Subject: Response to Requests for Additional Information in Support of the  
Staff Review of the Application to Renew the Facility Operating Licenses of  
McGuire Nuclear Station, Units 1 & 2 and Catawba Nuclear Station, Units 1 & 2

Docket Nos. 50-369, 50-370, 50-413 and 50-414

*Response to NRC Requests for Additional Information  
Concerning the Reactor Coolant System  
McGuire Nuclear Station and Catawba Nuclear Station  
NRC Letters dated January 28 and 30, 2002*

**SECTION K-K**  
**SCALE: 1/4" = 1'-0"**

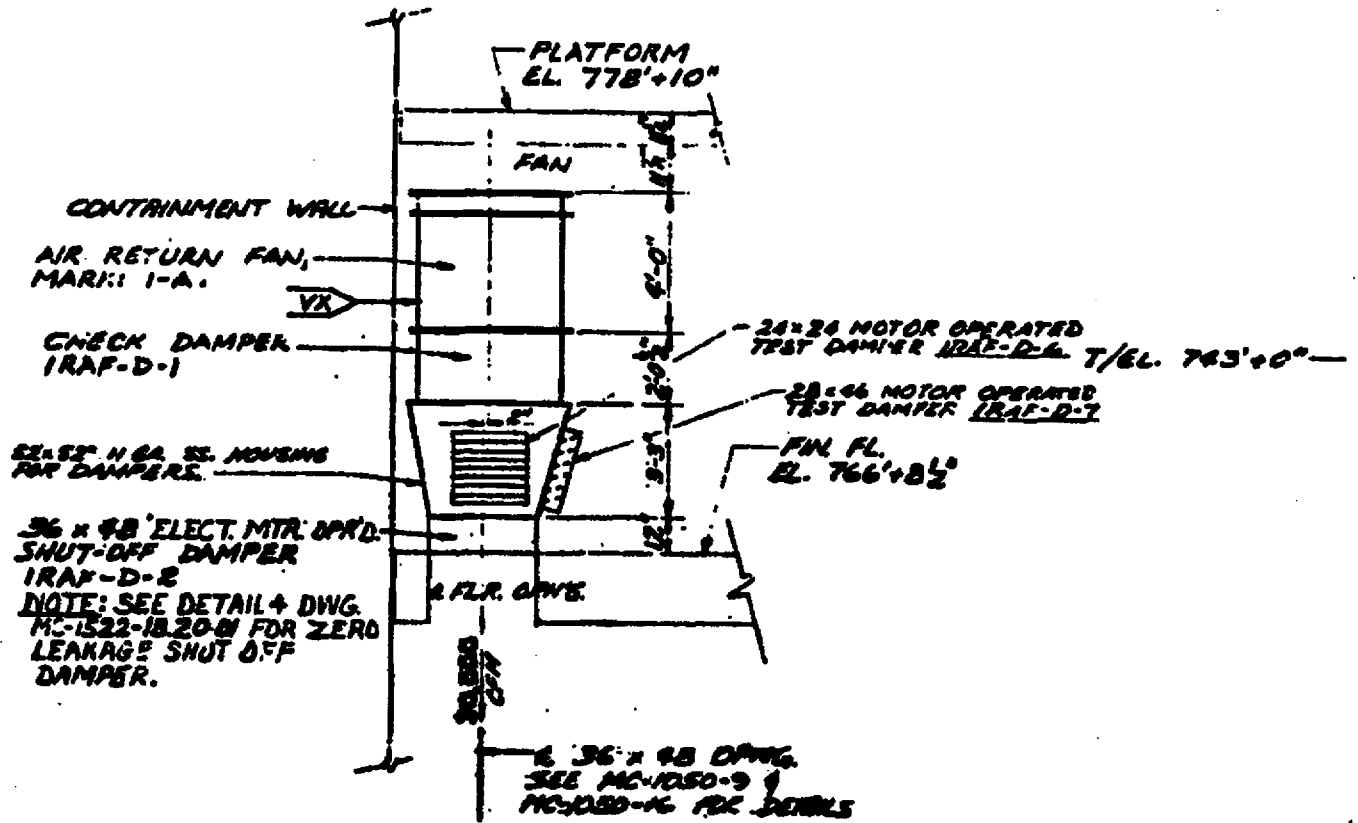
The staff and the applicant participated in a conference call on October 11, 2001. A summary of this conference call was issued November 14, 2001. The staff and applicant discussed drawings MC-1557-1.0, and MC-2557-1.0, specifically. The staff questioned why the ductwork between the containment air return fans and dampers was not considered to be a pressure boundary and not highlighted as within the scope of license renewal. The staff additionally noted that on drawings CN-1557-1.0 and CN 2557-1.0, the (apparently) analogous ductwork at Catawba was within the scope of license renewal. The applicant indicated that, for McGuire, the dampers are Quality Assurance (QA) Condition 1, safety-related, and within the scope of license renewal as noted by the highlighting on the referenced drawings. The ductwork, however, is classified as QA Condition 4, which is nonsafety-related. As such, only the hangers are within the scope of license renewal because of their function to hold up the ductwork in a seismic event. That is why the MNS drawings are not highlighted for the ductwork between the dampers. The applicant stated that leakage or failure is not a concern for this ductwork (i.e. a failure of the ductwork is not likely) during a non-seismic event. As such, the ductwork is not Class F and is not within the scope of license renewal.

Therefore, although the McGuire highlighted drawings are confusing, there are no components missing from within the scope of license renewal. A corrective action report has been entered into the corrective action program to clarify the flow diagrams MC-1557-1.0 and MC-2557-1.0.
